December 11, 2007

The California Department of Transportation (Caltrans), Division of Aeronautics (Division), reviewed the proposed Victorville 2 Hybrid Power Project (Victorville 2) Site Plan and proposed site on October 4, 2007 with Peter Soderquist, manager of the Southern California Logistics Airport (VCV). We also conducted overflights of two similar existing sites, known as Kramer Junction and Harper Lake, respectively, located between Edwards Air Force Base and Barstow, California.

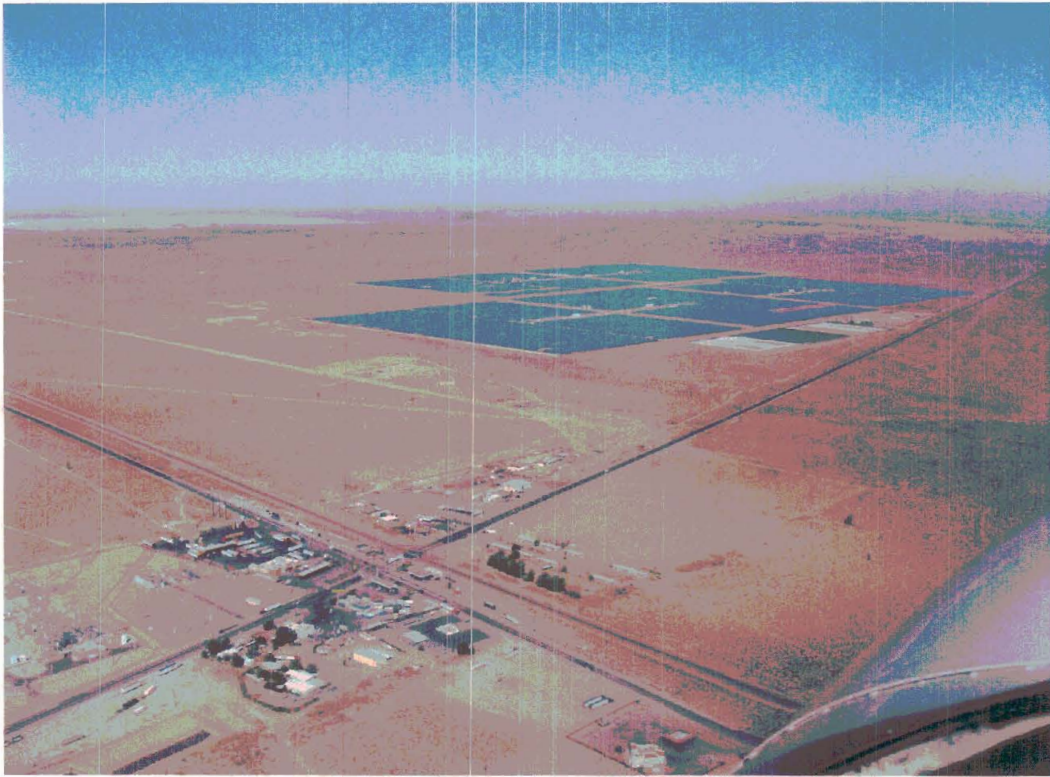
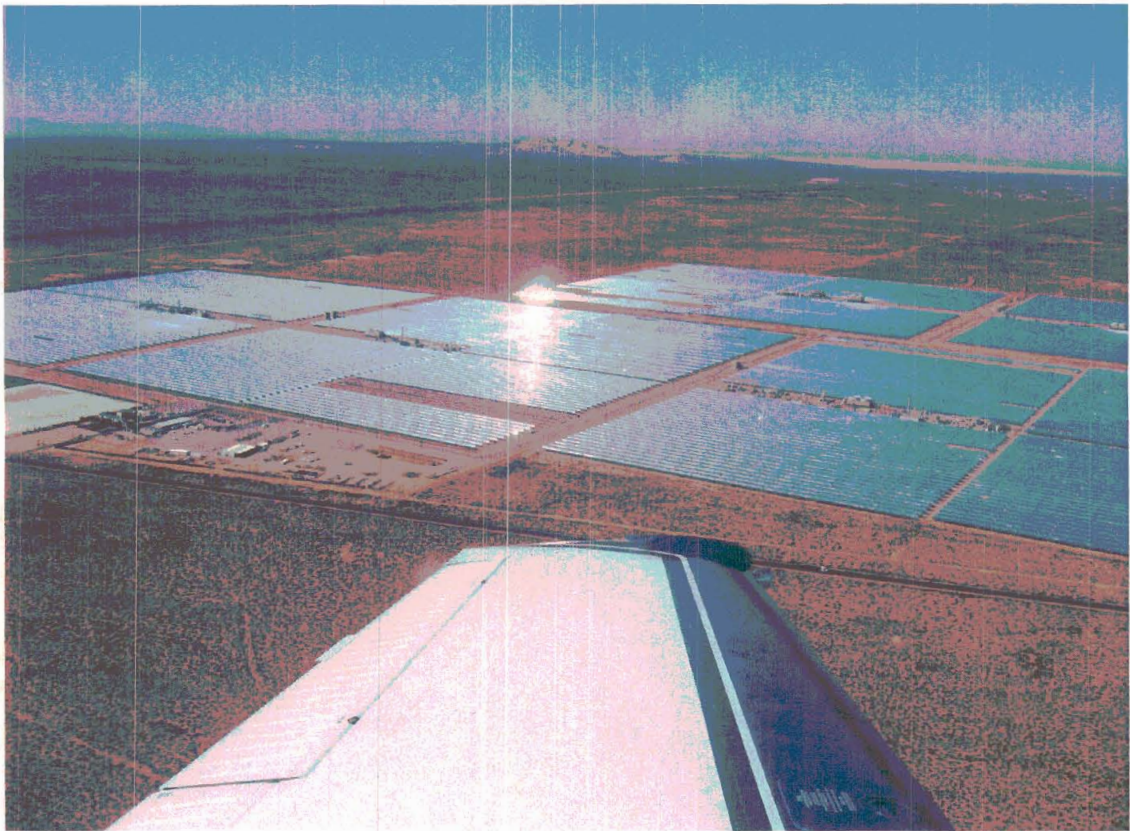
The proposal is for the construction a 250-acre solar array and support infrastructure near the approach end of Runway 17 at VCV. As part of our review, the Division relies on Federal Aviation Administration (FAA) aeronautical studies to evaluate whether proposed structures near airports are flight hazards. The studies are required by Federal Aviation Regulation (FAR) Part 77, "Objects Affecting Navigable Airspace." FAR Part 77 is a FAA regulation and is available on-line at <https://oecaaa.faa.gov/oecaaa/external/portal.jsp>. FAR Part 77, does address hazards to flight; however, it does not address other types of hazardous material, features, or affects created by similar projects. Therefore, we conducted overflights, both at low altitude and traffic pattern altitude, to simulate conditions proximate to those that might be found at Victorville 2. At approach altitudes of 200 to 300 feet, we found no unusual turbulence or thermal plume rising from the surface of the solar array. The consistency of the surface at the two existing facilities and the turbulence directly above and downwind of the surfaces was roughly similar to overflight of a smooth water surface. We found the reflections to be somewhat sharper and cleaner than those compared at the same time over water; however, the flash and distraction level appeared to be the same by four observers, in two separate light aircraft. (See enclosed photographs.)

The Division has no objection to the proposed project, based on aircraft operational safety, provided:

- The project sponsor submits a Notice of Proposed Construction or Alteration (Form 7460-1) to the FAA and then obtains a no-hazard determination from the FAA prior to beginning construction.

- The VCV Airport has no objection to the facility.
- The project is compliant with the provisions of the California Environmental Quality Act.
